Technical Bulletin

45C Viewmast® II Channel Spacer Kit 675277 Installation Instruction

MODEL: 45C Viewmast® II Quad Lift Masts

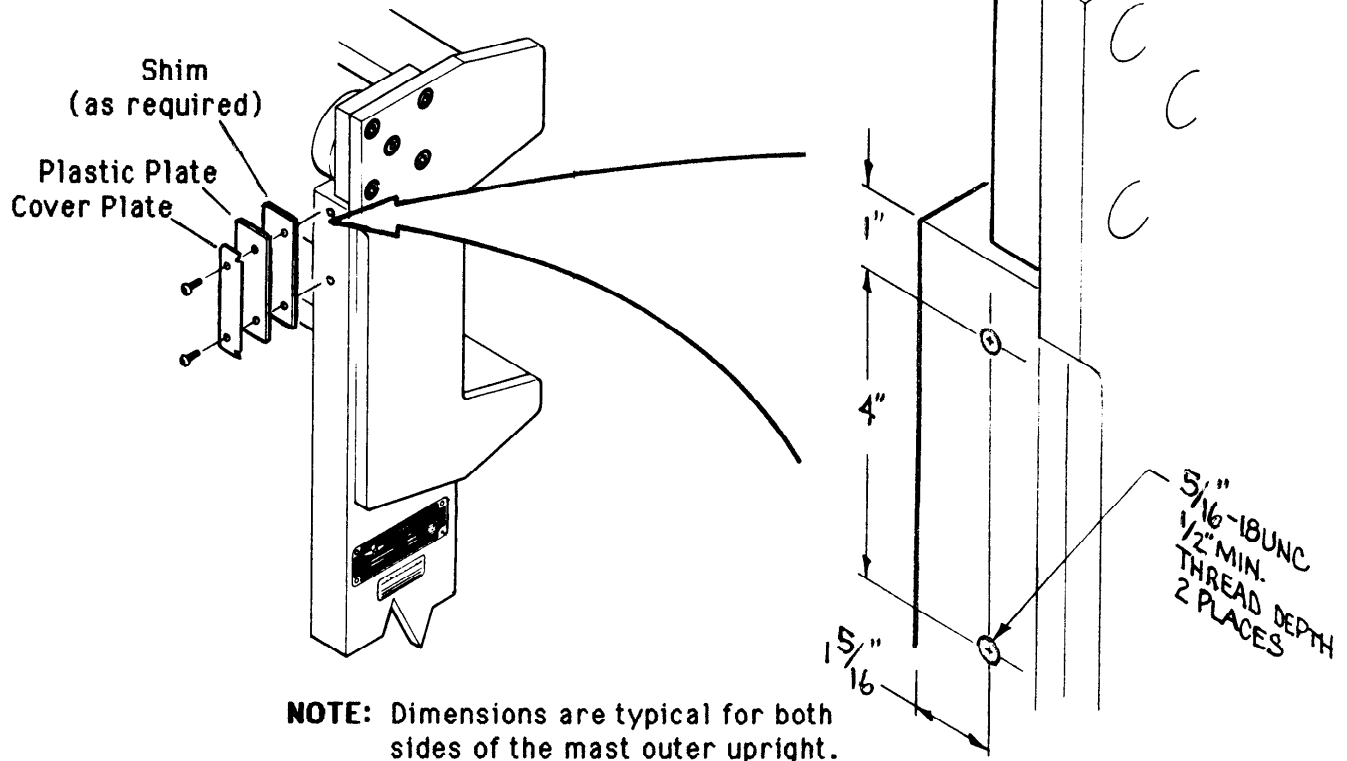
PROBLEM: When the mast is fully extended the outer channel load rollers are wearing excessively on the inner surface of the intermediate upright.

SOLUTION: Install Channel Spacer Kit 675277 to the outer upright at the locations shown below. The spacer kit will take up space between the outer intermediate channel and outer channel to eliminate the wear problem. The spacer kit includes the following parts:

- 2 675278 Cover Plates
- 2 675279 Plastic Plates
- 6 675280 Shims
- 4 4870 Capscrews, 5/16 NC X .62
